### TB 59

#### STANNAH LIFTS LTD

# **TECHNICAL BULLETIN**

**Product:** Stairiser SX, external model

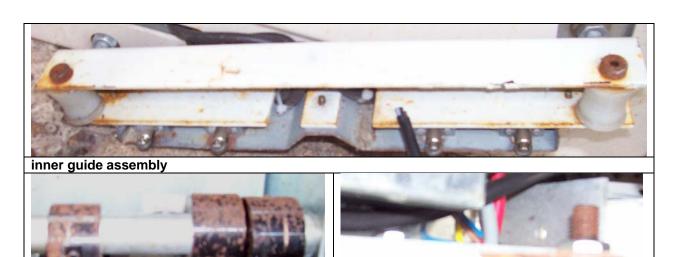
3 components located on Stairiser SX external units manufactured before July 2007, have been found to suffer rusting due to an incomplete coating process. It is considered prudent that these components should be inspected & monitored in the field during service.

It is requested that the following 3 components are inspected & monitored for signs of excessive rusting in line with normal inspection practice. If it is considered that the integrity of any component has been affected, the component shall be replaced & sent back in accordance with the component warranty returns procedure.

barrier arm actuator cams

seat hinge bracket

The service routine should include an application of light grease to the affected components.
